KINGSCLIFF RATEPAYERS and PROGRESS ASSOC. Inc
PO Box 1164, Kingscliff, NSW

Our Association thanks you for the opportunity to comment on the proposed modification to the Casuarina Town Centre by the Clarence property Group.

Document: Section 75W Modification No. 10

**SUBDIVISION LAYOUT PLAN
STAGE 1E - DETAIL 2**

Yield Estimate

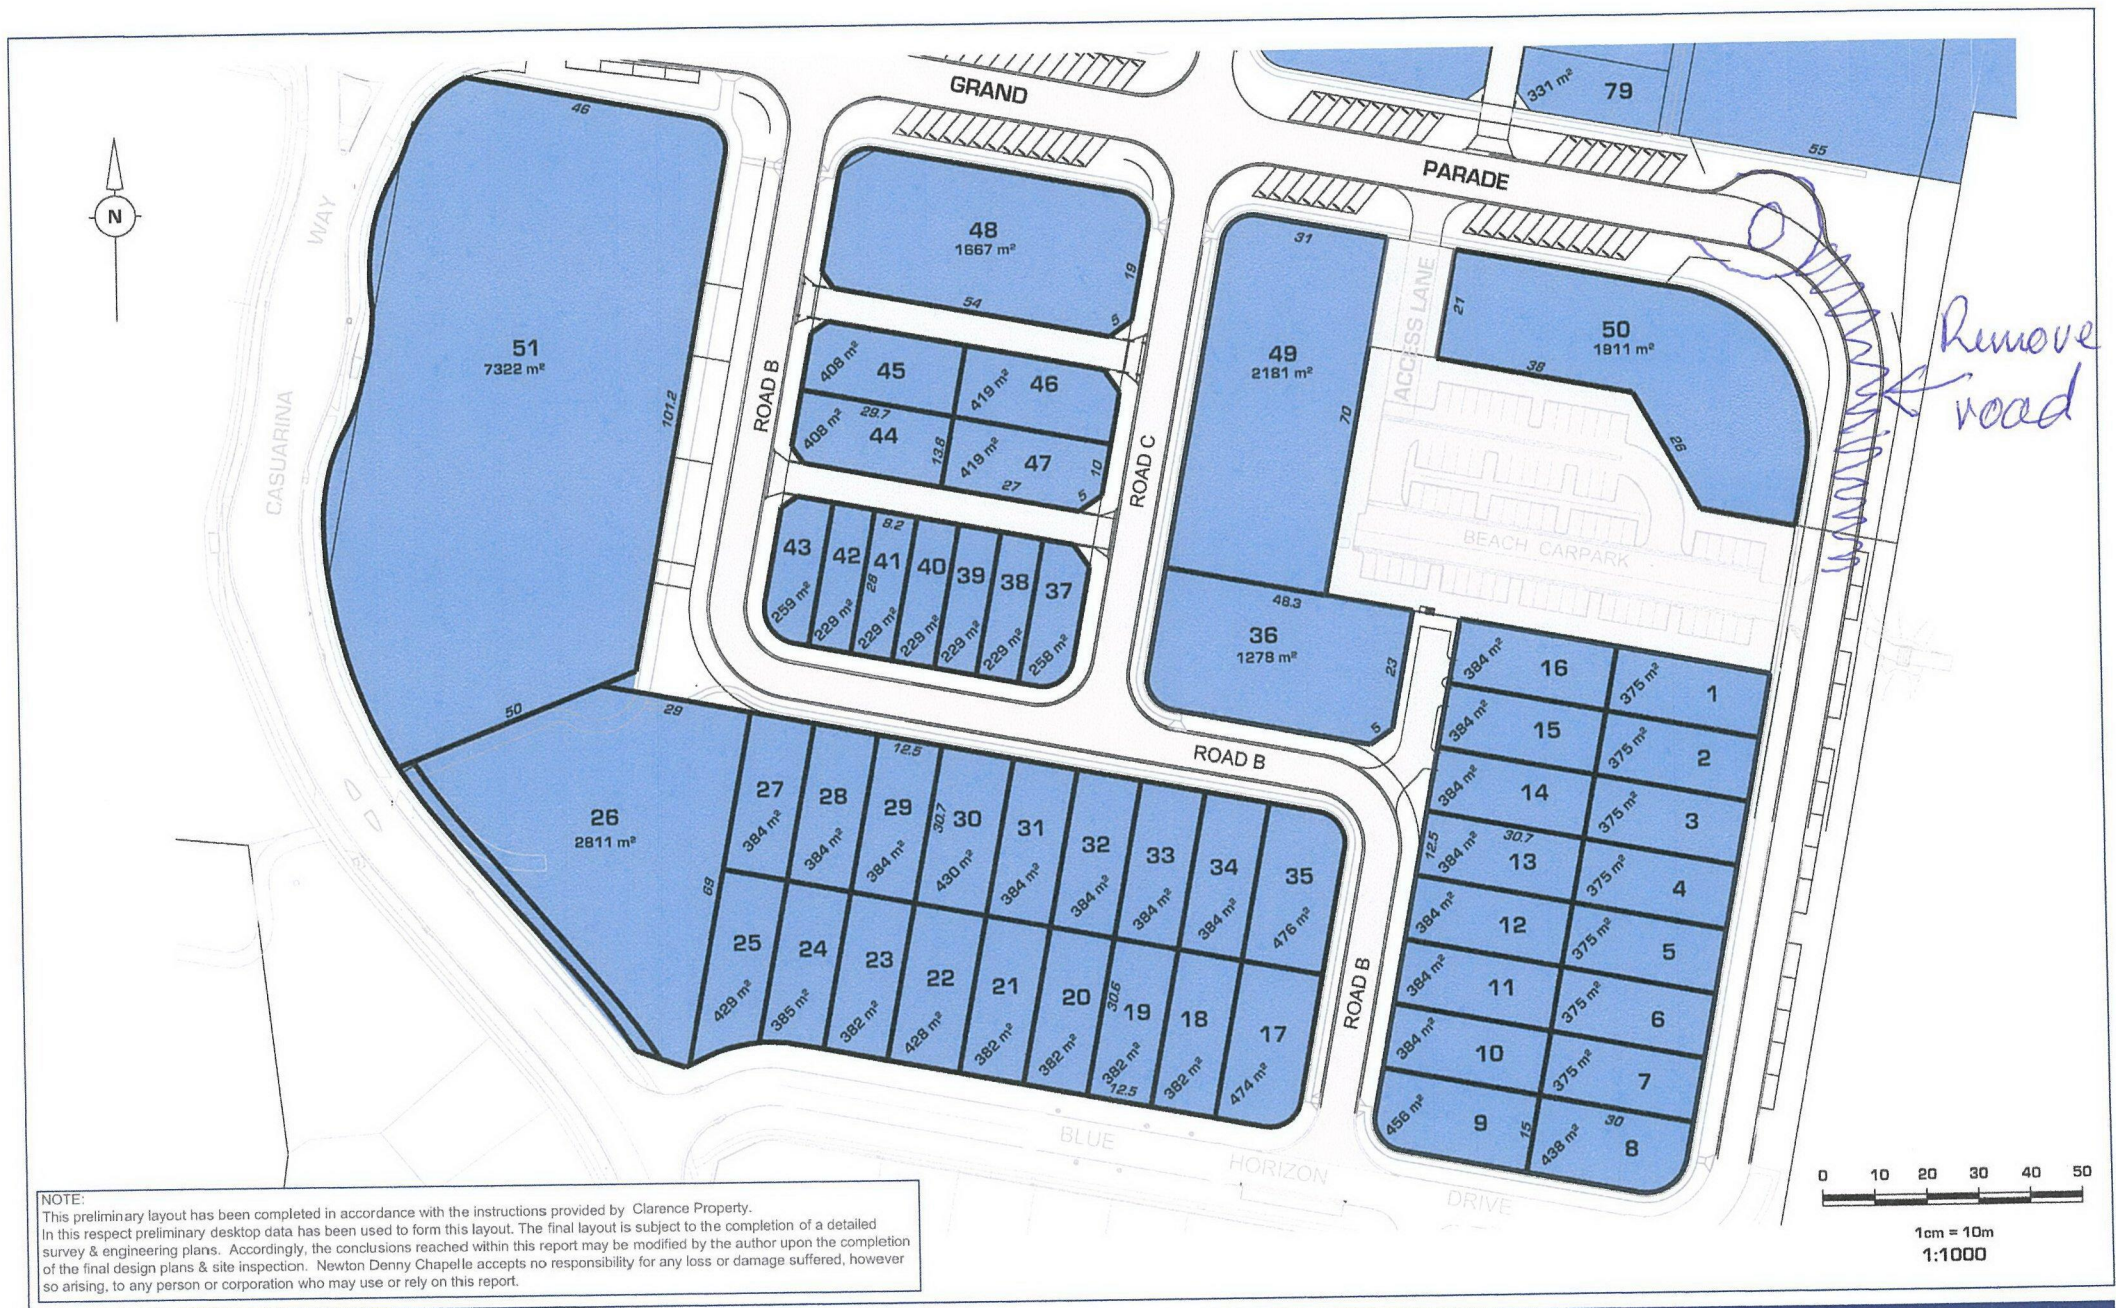
We request that all car parking, and visitor parking, for the residential properties be placed under the buildings.
